DEVIATION REQUEST AND DECISION FORM

Project Name :	Mayberry Phase 1 PUD Amendment
Schedule No.(s) :	3414201030
Legal Description :	See attached plan sheet

A deviation from the standards of or in **Section F SD_2-77 "Urban Knuckle"** of the Engineering Criteria Manual (ECM) is requested. Please refer to the Deviation Exhibit Nos. 1a, 1b, 2 and 3. The specific locations are shown in Deviation Exhibits 1a and 1b.

Deviation Exhibit 2:

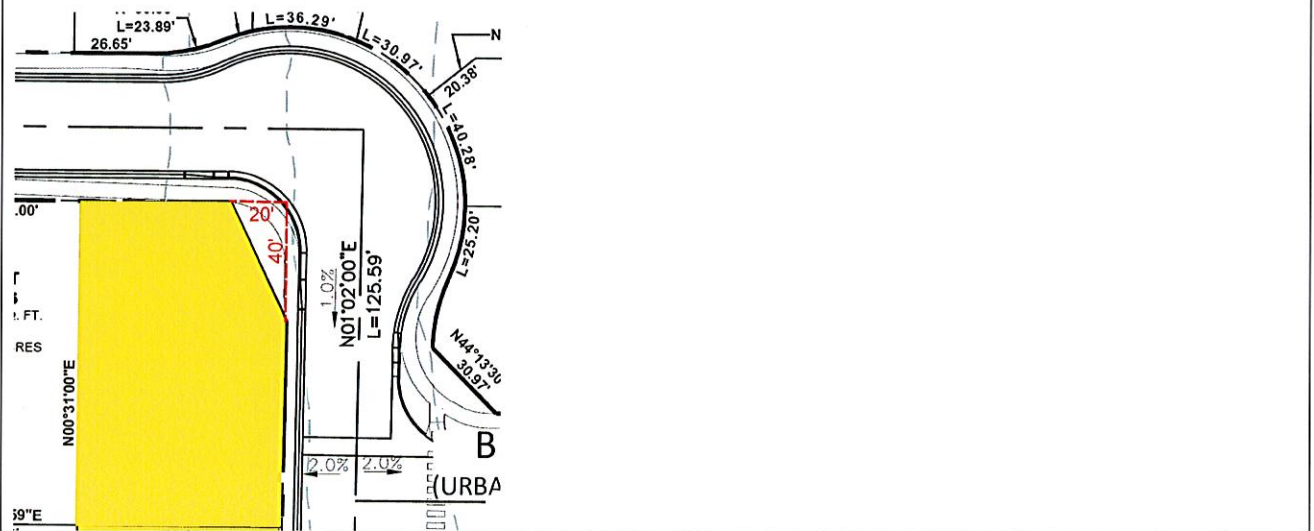
The proposed alternative, shown in the attached Deviation Exhibit 2 (below), would modify the length of the standard sight-distance-triangle leg from 40' and 20' along the street leg (extending back from the knuckle) onto which the corner lot will have driveway access. This is shown for several locations, which are shown in the attached Deviation Exhibits 1a and 1b. A copy of the ECM Urban Local Knuckle standard plan sheet (SD_2_77) is also attached for reference. The standard plan sheet shows several standard dimensions, including the inside radii and the sight-distance triangle (SDT) dimensions.

Deviation Exhibit 3

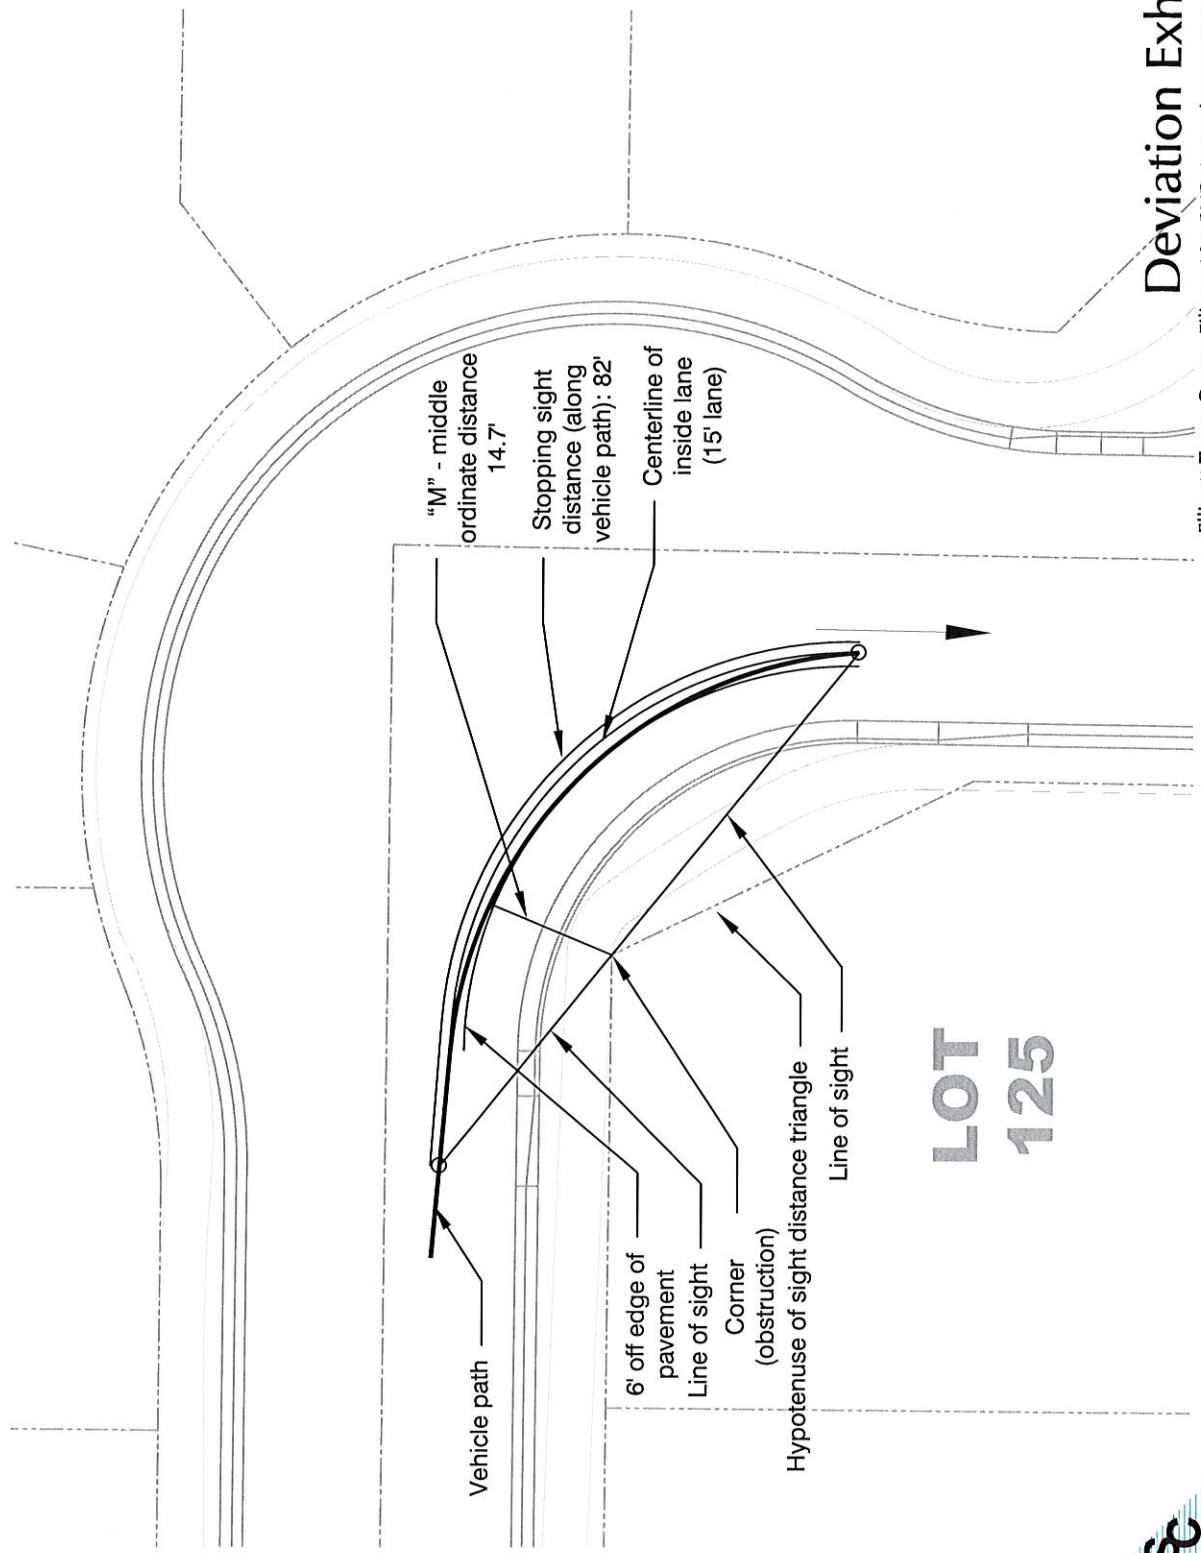
The inside edge of pavement radius is 37 feet (the same as SD_2_77) and the centerline radius through this 90-degree curve/knuckle is 52 feet. Please refer to the attached Deviation Exhibit 3. Assuming a design speed of 15 mph around the curve of this knuckle, the required stopping sight distance is 80 feet. Based on Figure 2-21 in the ECM, the required "M," middle ordinate distance, centerline of inside lane to obstruction is 14.6 feet. Exhibit 3 shows the M value for the proposed sight-distance-triangle leg lengths. The measured M is 14.7. Therefore, the Stopping Sight Distance, 82 feet, on Horizontal Curve 2.3.6.C would be met.
